EAST ROSWELL LIBRARY
ADDENDUM NO. 07.1-3
APRIL 25, 2013

This Addendum No. 07.1-3 dated April 25, 2013 issued by Ajax Building Corporation of Georgia is hereby made part of Bid Package 07.1 – ROOFING for the East Roswell Library. The changes and/or clarifications included in this Addendum shall be considered as part of the Bidding Documents and shall supersede, amend, add to, or subtract from those conditions included in the original Bidding Documents, including the Project Bid Package, Drawings, Specifications, previous Addenda, etc. This Addendum must be acknowledged in the space provided on the Proposal Form (included in Section II of the Bid Package). Failure to acknowledge this Addendum may subject Bidder to disqualification.

Job Id: 201209 **Name:** East Roswell Library	**RFI No.** 006 **Reference:** 2/A5.70, A3.10 **Issue Date:** **04/23/2013** **Requested by:** **04/30/2013**
Issued To: Khafra Attn: John Ray 1601 5th Avenue, North Birmingham, AL 35203 jray@khafra.com	**Issued By:** Ajax Building Corporation Attn: Rebecca Bailey 5950 Shiloh Road East, Suite S Alpharetta, GA 30005 rebecca@ajaxbuilding.com

Receiver's Reply:
Piedmont Pipe Downspout - Model SO

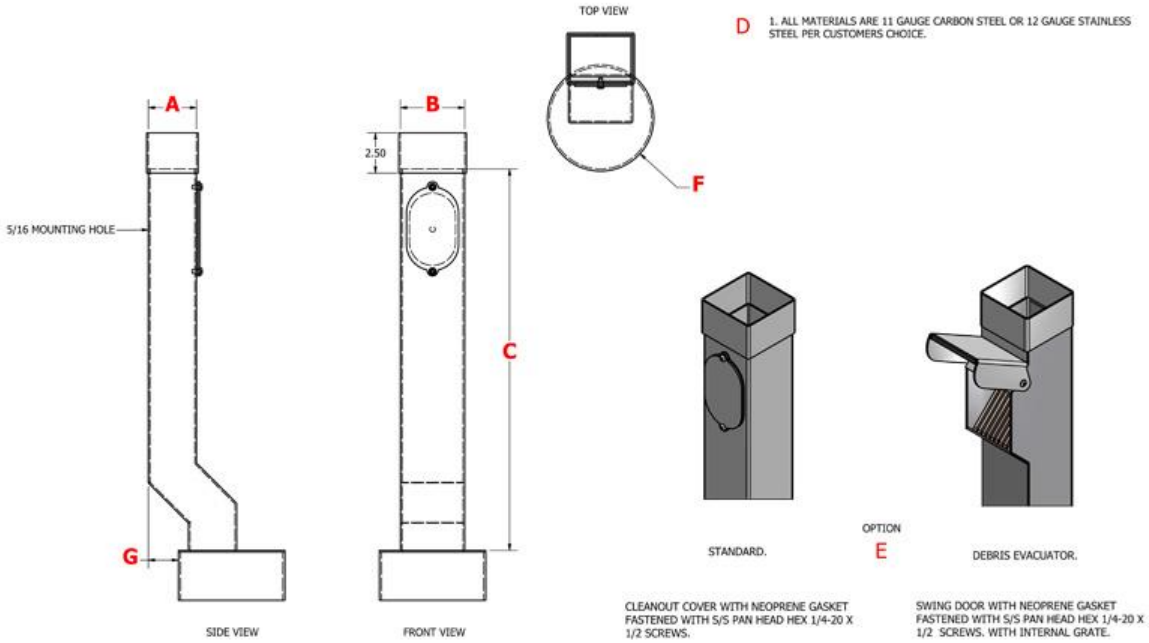
Please provide Body Length and Offset Size for downspout boots.

A: To Receive 8" Diameter OD Downspout
B: To Receive 8" Diameter OD Downspout
C: 24"
D: 304 Carbon Steel with Manufacturer's standard black finish
E: Standard Cleanout
F: To connect to 8" Storm drain
G: 4" off set
